BOULDER COUNTY PLANNING COMMISSION PUBLIC HEARING

STAFF RECOMMENDATION

Docket SU-20-0003: Jubilee Acres Reception Hall

Proposal: Special Use and Site Specific Development Plan request for a reception hall to host weddings and other events approximately 150 times per year on a 36-acre parcel.

LANDSCAPE
DETAILS

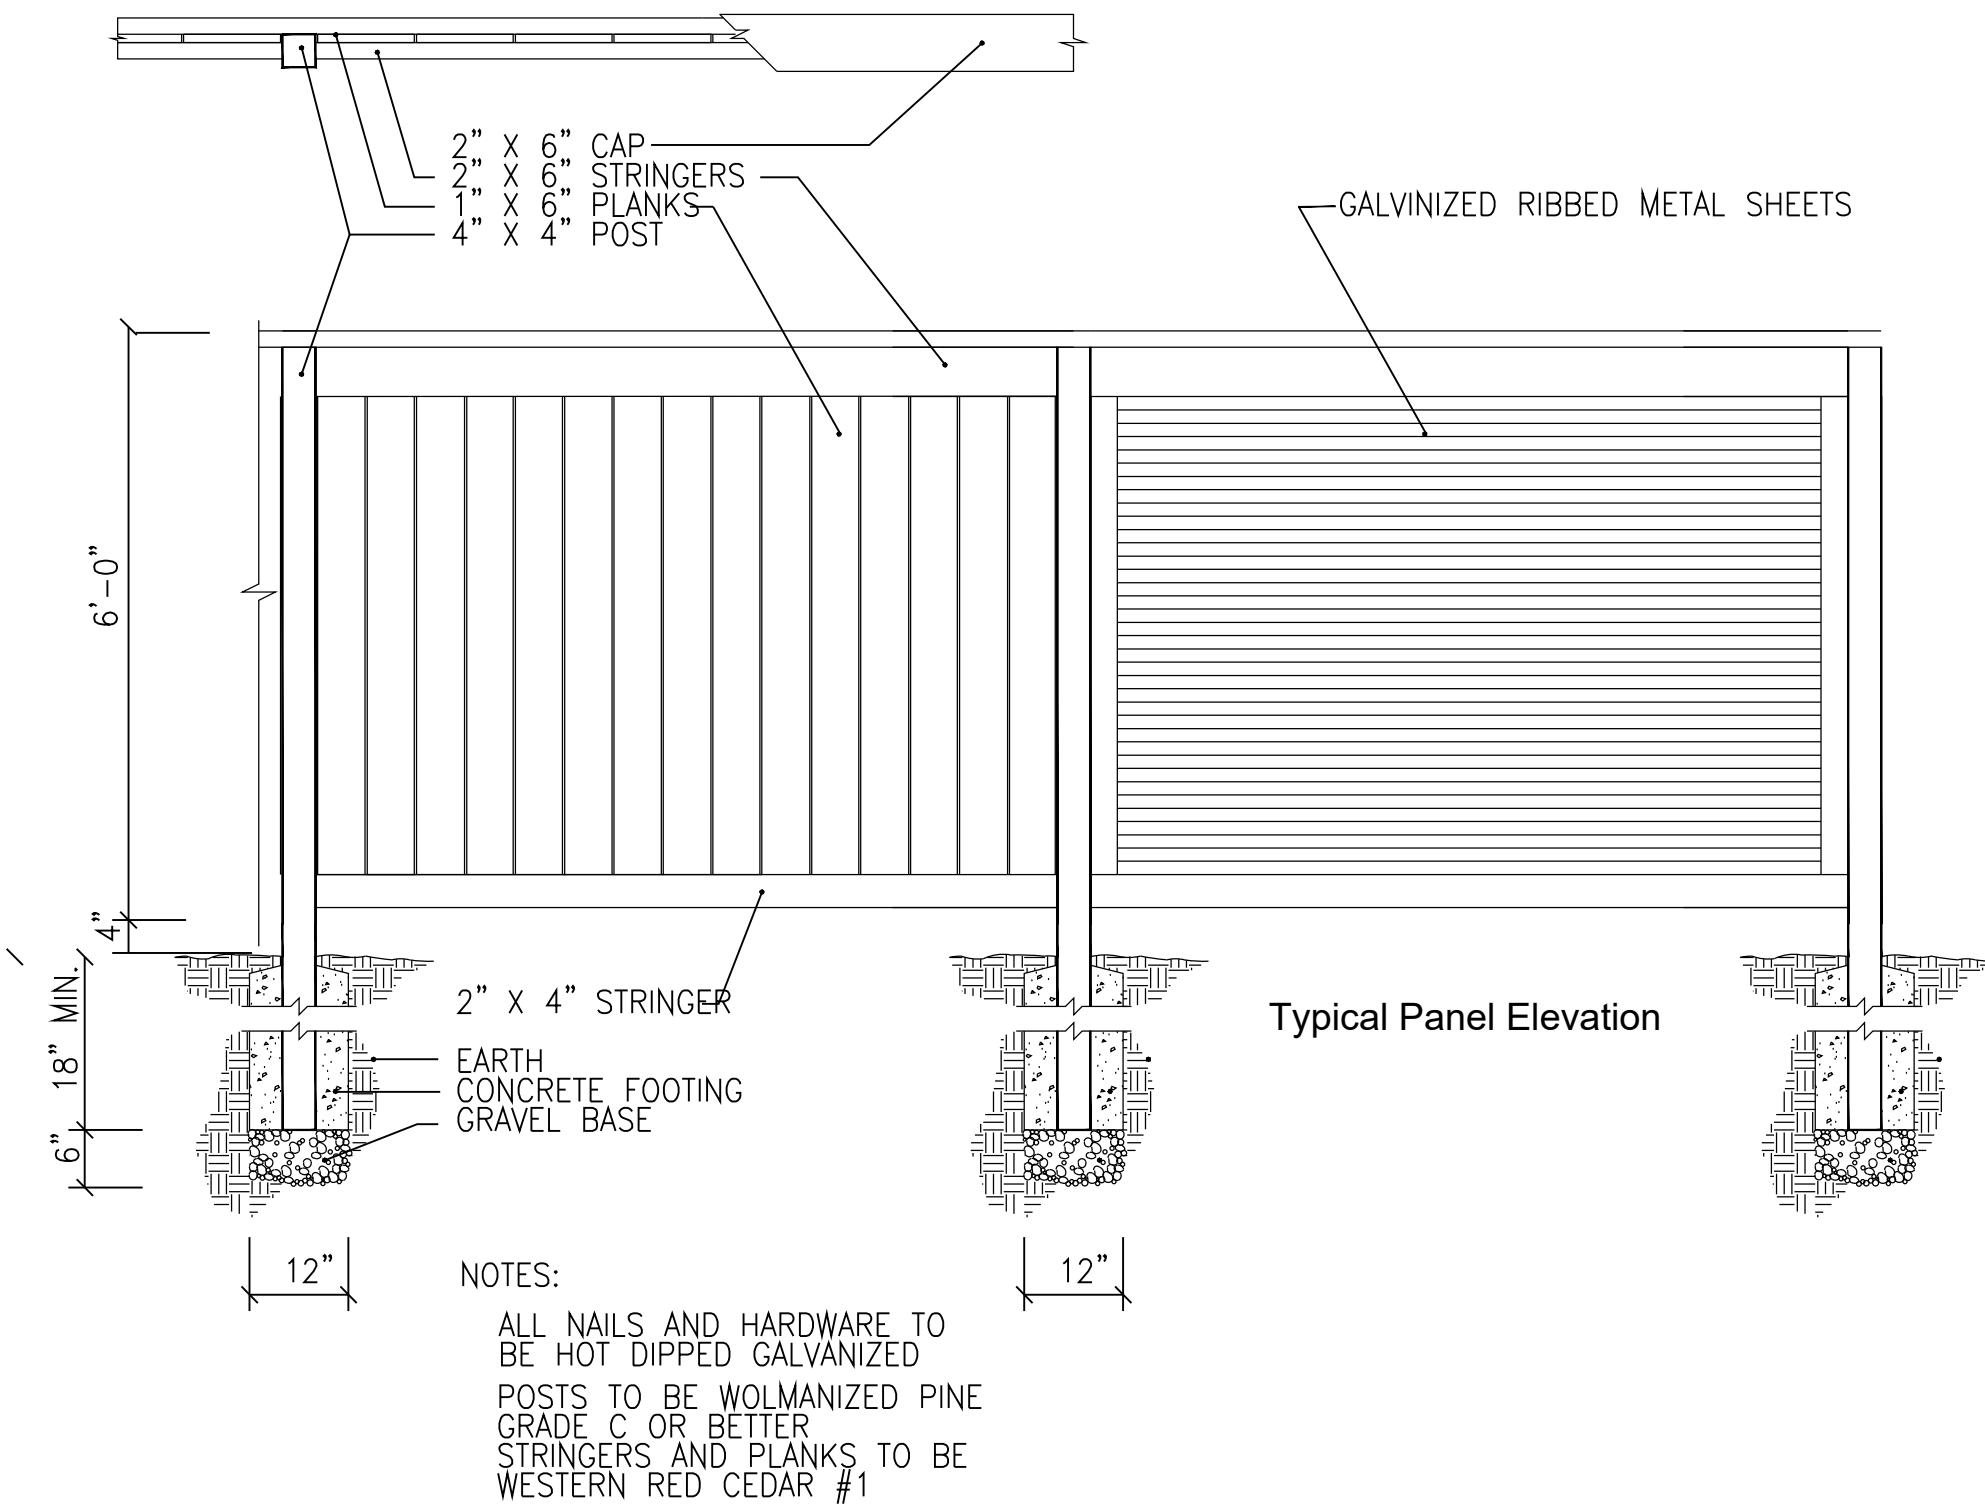
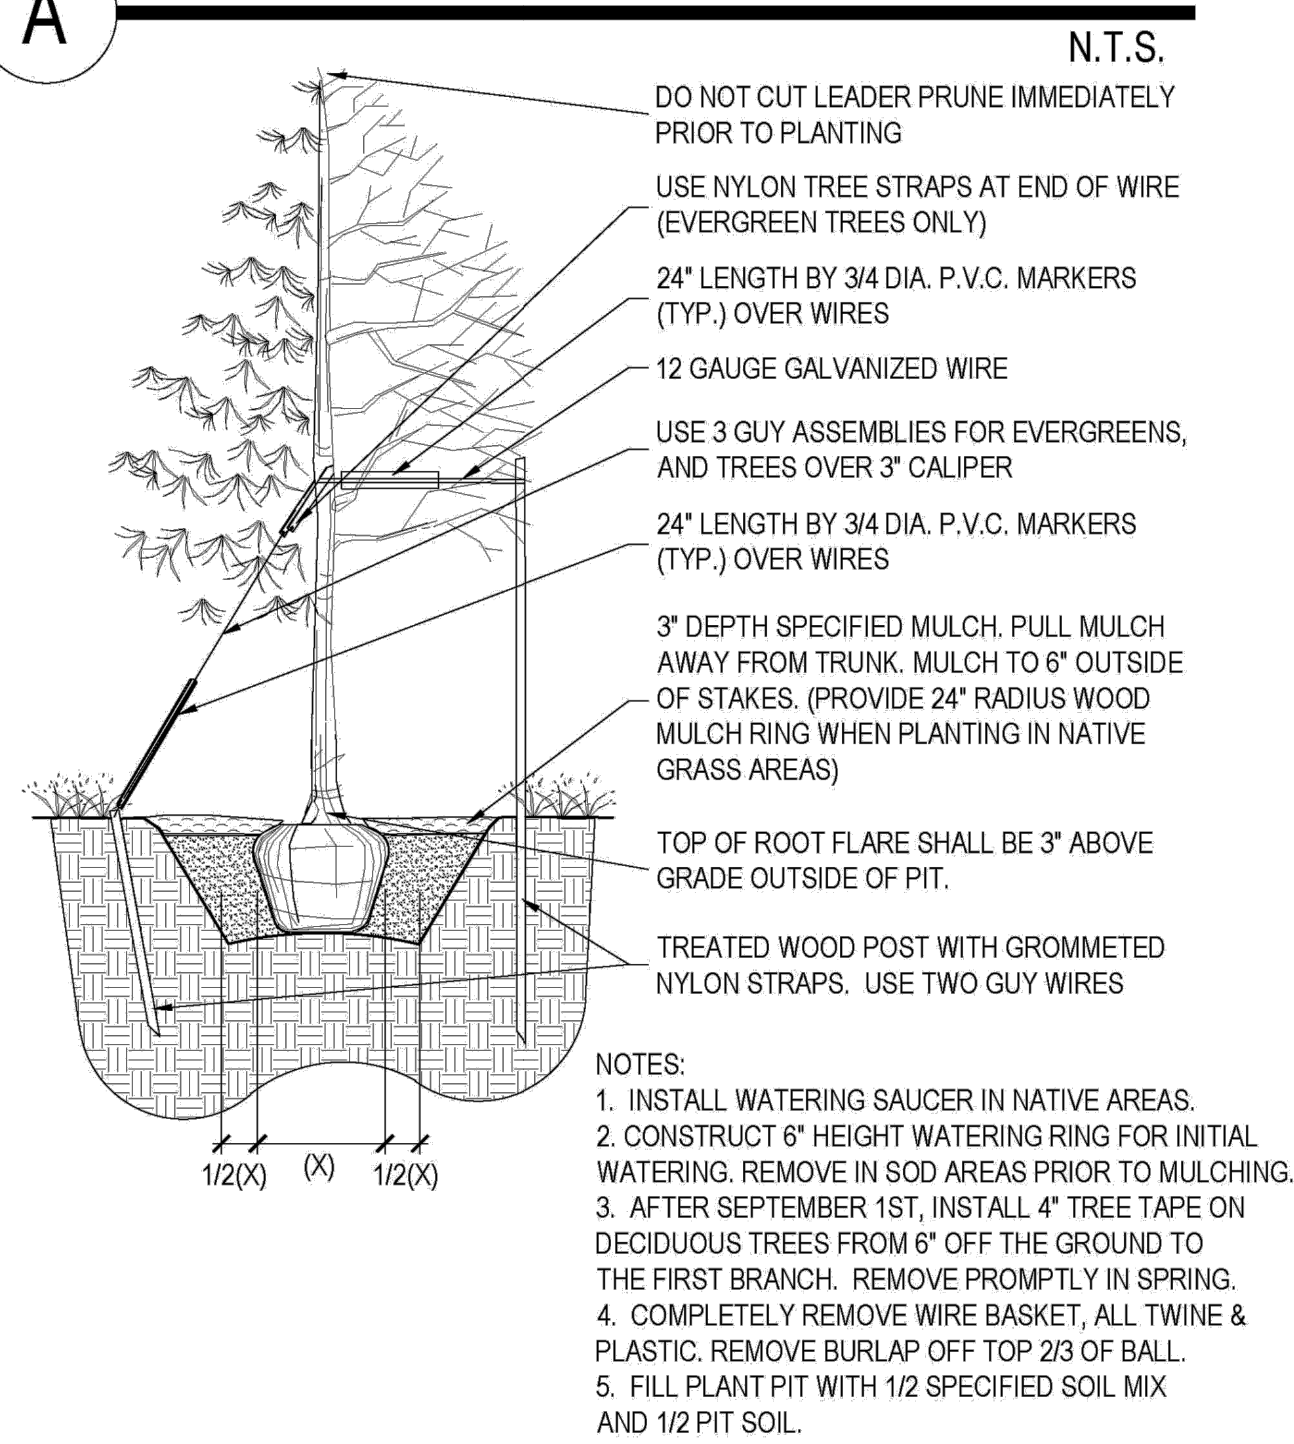
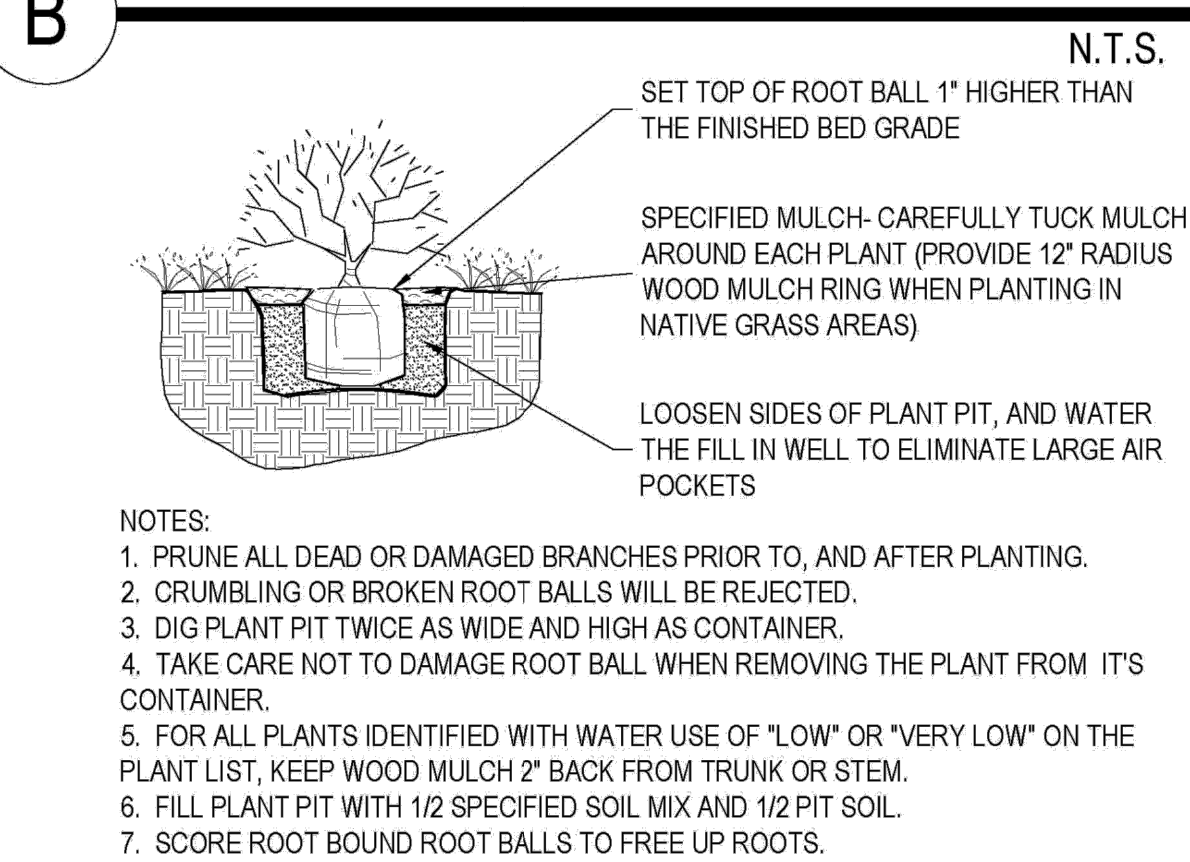
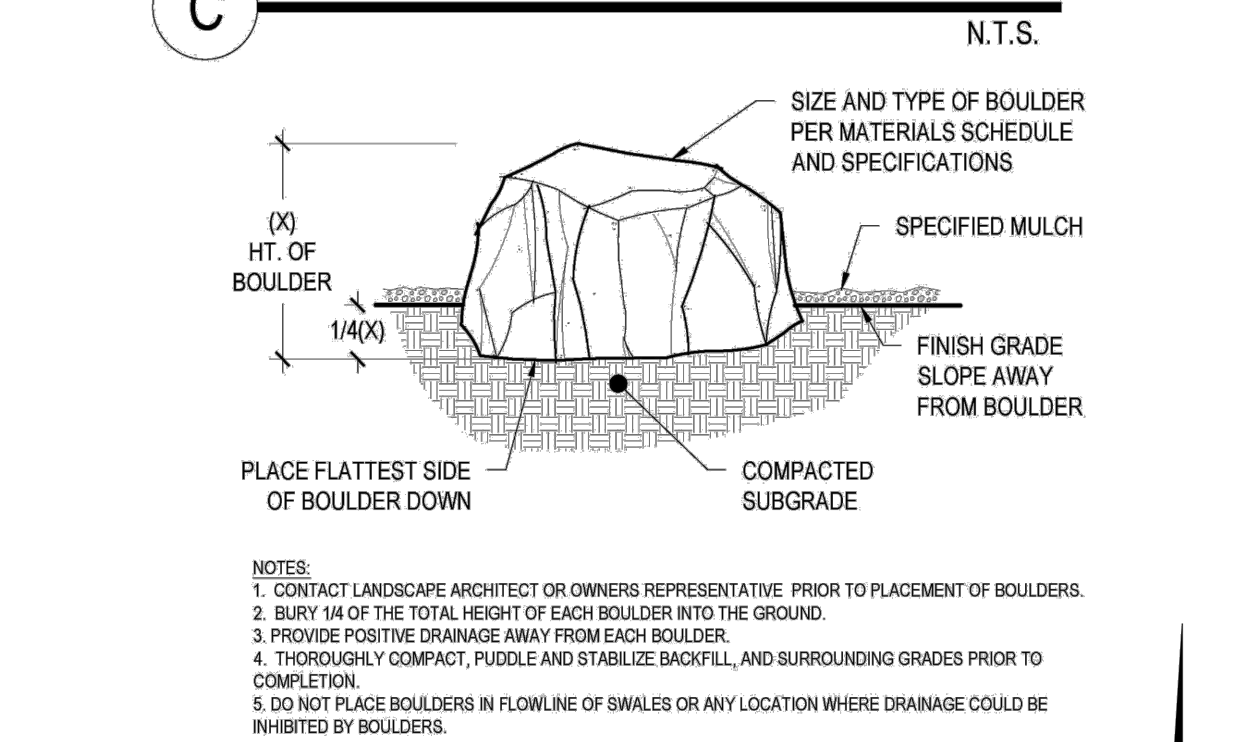
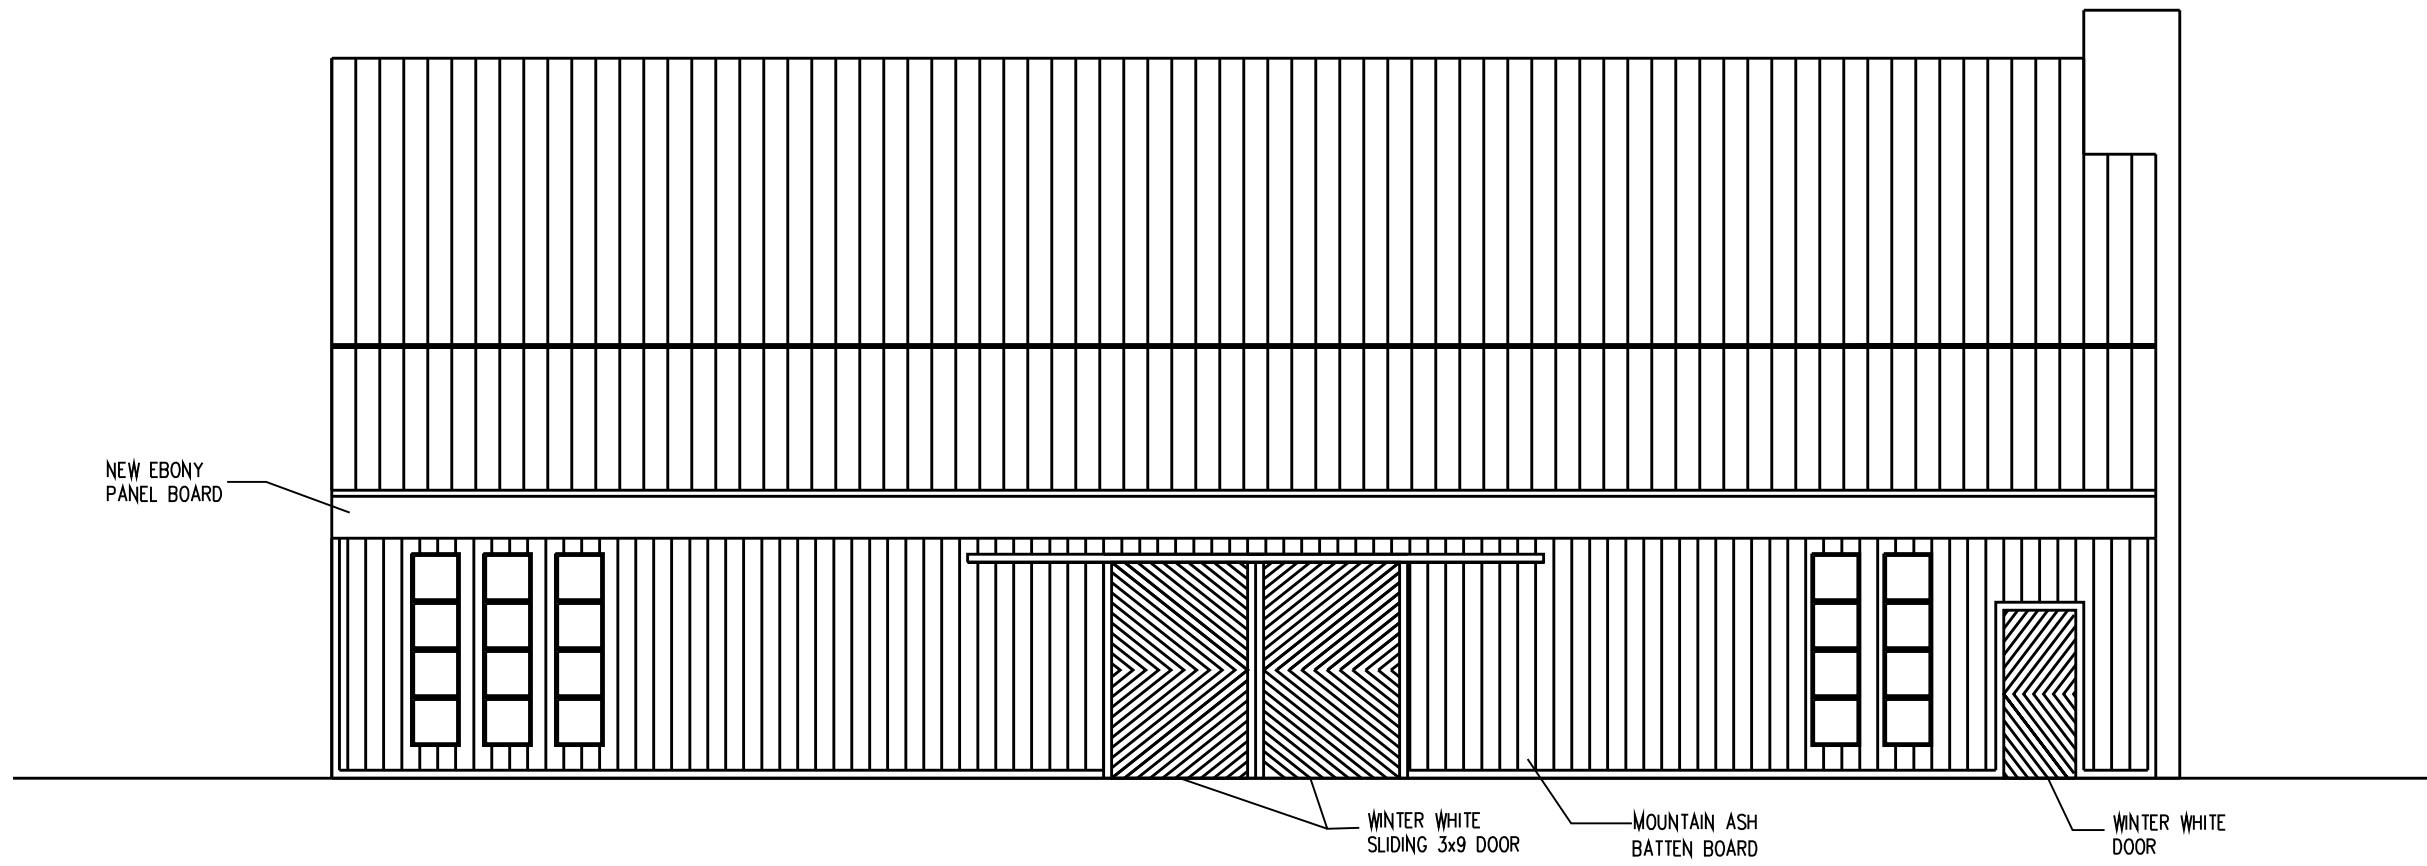
Can Supply Ditch water be used for "recreational" uses in the pond, or for horticultural irrigation, as opposed to agricultural irrigation. Drawing LS-1.1 states that, "All landscape areas within the site shall be irrigated with an automatic underground irrigation system." Is the use of ditch water compatible with this, or would potable water from Little Thompson Water be necessary for underground horticultural irrigation? The latter is not a sustainable used of treated water.

LS-1.1 – All of the plant species shown – plantings and grass seed – are acceptable. Staff questions whether Gingko would survive this exposed location.
